Application for Five Variances, Each Subject to Three Conditions, Respecting One Third Party Electronic Ground Sign - 10 Morse Street

Date: April 22, 2025

To: Sign Variance Committee

From: Project Director, Business Transformation and Citywide Priorities, Toronto Building

Figure 3: Third party signs in the area in the year of 2012 (as per Sign View Map)

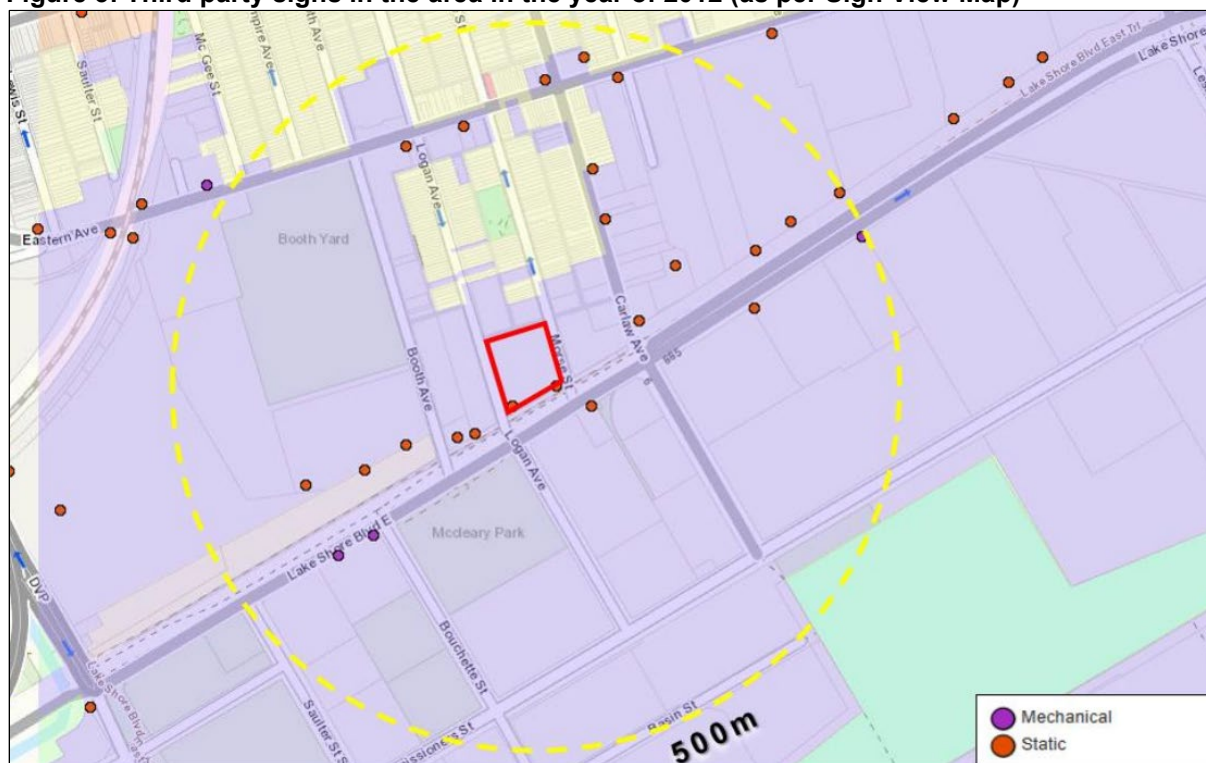
E Sign Districts are areas within the city permitted in the Sign By-law to accommodate third party electronic ground signs, like the Proposed Sign. Historically, there have been several third party ground signs along this portion of Lake Shore Boulevard East, between Don Valley parkway and Leslie Street (see Figure 3).

The Applicant's submissions indicate that a number of long-standing third party ground signs are present in the area, contributing to its character (see Figure 3). Staff investigation revealed that signs have been present along Lake Shore Boulevard East for many years, predating the current Sign By-law.

Figure 7: Location of the Proposed Sign in relation to the existing third party signs in the area

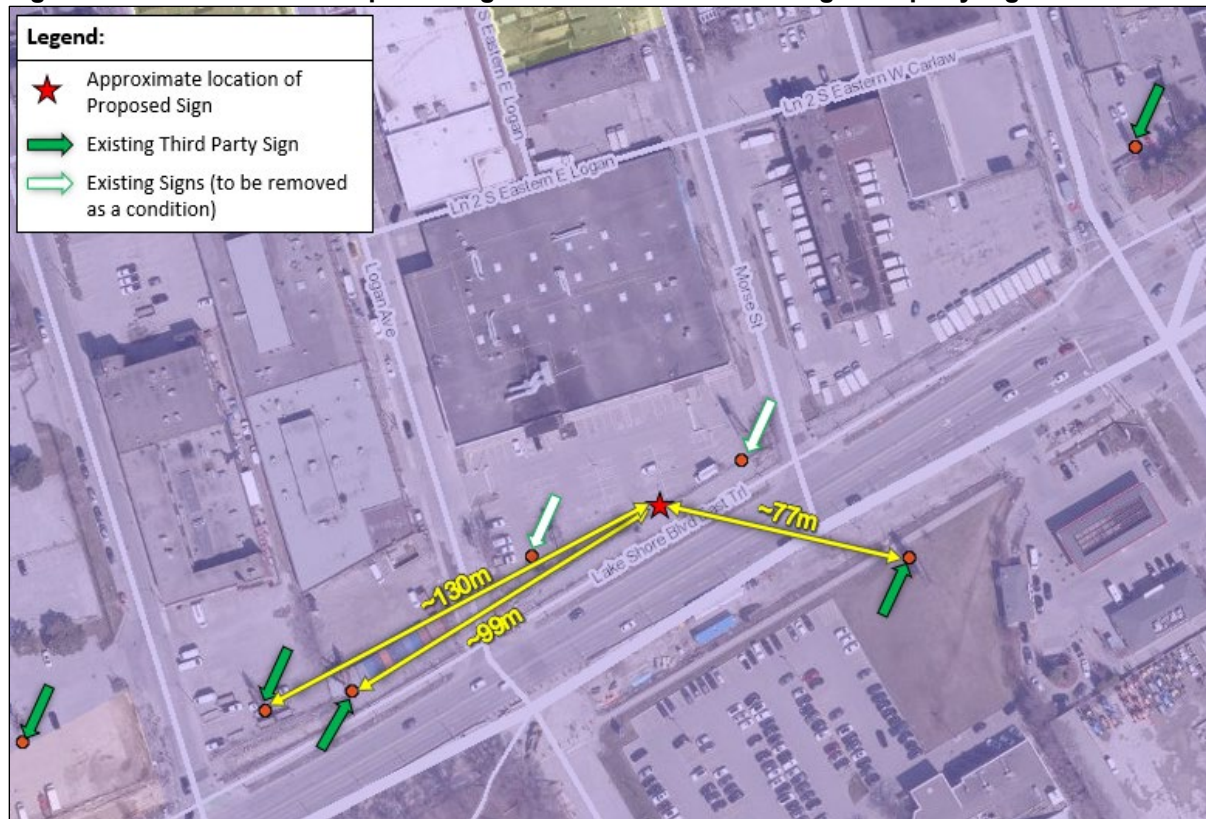
The Applicant seeks a variance to place the Proposed Sign within 150 meters of three existing third party signs displaying static copy, conflicting with the Sign By-law's separation requirements. The nearest sign is approximately 77 meters southeast of the Subject Premises, nearly half of the required separation distance. Consideration must be given to the large number of signs in the immediate area and their proximity to the Proposed Sign to determine if this raises concerns about sign clutter and compatibility with the area's character.

The surrounding area may have been deemed appropriate for a high density of third party signs in the past, but it has since been subject to City Council decisions aimed at reducing sign density. The Sign By-law's separation requirements, among other things, aim to prevent multiple sign faces from being visible simultaneously. The Proposed Sign

and nearby third party signs will likely be visible simultaneously to drivers along Lake Shore Boulevard East (see Figure 8).
